SUBDIVISION REVIEW SHEET**CASE NO.:** C8-2020-0112.1A**COMMISSION DATE:** August 16, 2022**SUBDIVISION NAME:** Braker Valley Subdivision (a small lot subdivision)**ADDRESS:** 4806 Blue Goose Rd**APPLICANT:** RR Braker Valley, LP (Jeremy Smitheal)**AGENT:** BGE, Inc. (Chris Rawls)**ZONING:** I-SF-4A (single family residence, small lot subdivision)**NEIGHBORHOOD PLAN:** N/A**AREA:** 68.615 acres**LOTS:** 211**COUNTY:** Travis**DISTRICT:** 1**WATERSHED:** Walnut Creek**JURISDICTION:** Full Purpose

**CITY OF AUSTIN –DEVELOPMENT SERVICES DEPARTMENT
SUBDIVISION APPLICATION – MASTER COMMENT REPORT**

CASE NUMBER: C8-2020-0112.1A
 UPDATE: U1
 CASE MANAGER: Joey de la Garza PHONE #: 512-974-2664

PROJECT NAME: Braker Valley Subdivision Final Plat
 LOCATION: 4806 BLUE GOOSE RD

VICINITY MAP
NOT TO SCALE

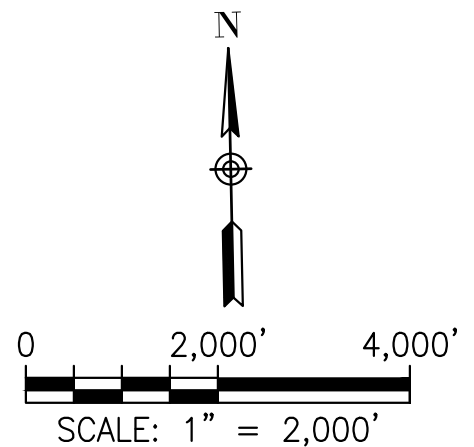
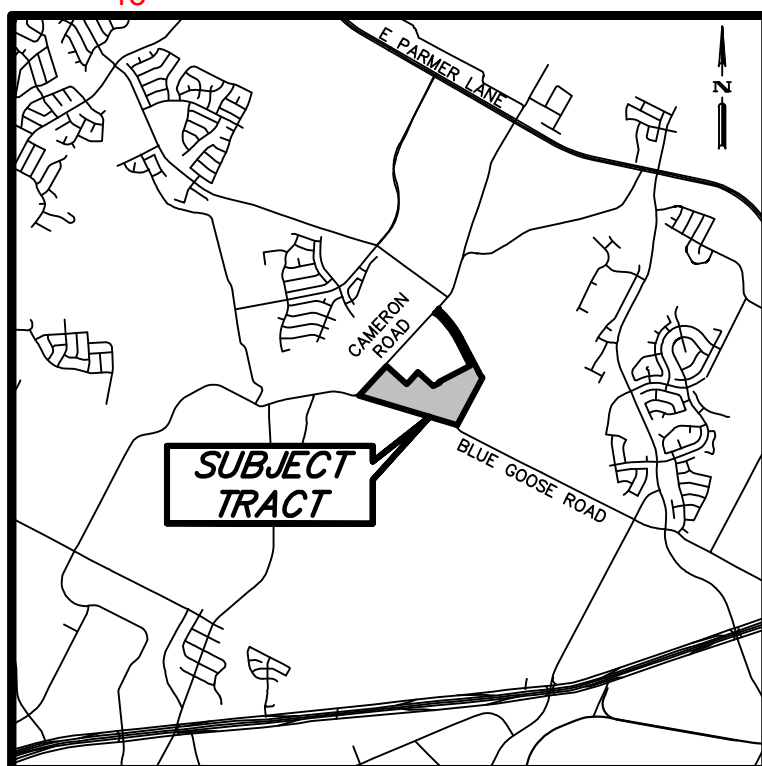
AD2: In the vicinity map, add a label for **E BRAKER LN**
